Hi-Fi Products
Service Bulletin

Model: TC-H3600

No. 224R1

Subject: Unit Contains Fuse Links On Power Board Which
Are Not Referenced in the Service Manual.

[POWER BOARD]

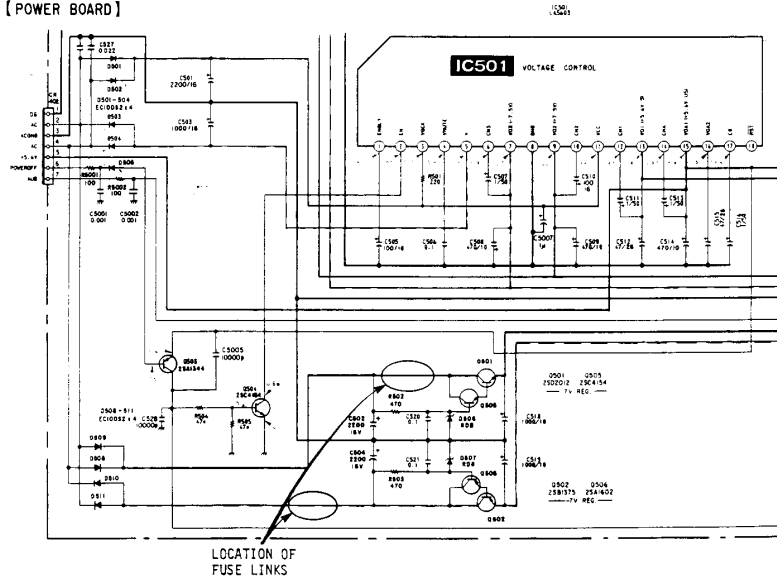
The unit has (2) 2.5A fuse links, the first connected in series with the collector of Q501 and the bridge rectifier and the second connected in series with the collector of Q502 and the bridge rectifier. The Service Manual does not reference these parts.

Solution: The correct part number and schematic location of the fuse link described above are shown below:

DESCRIPTION	PART NUMBER
FUSE, MICRO (2.5A, 125V)	1-532-780-21
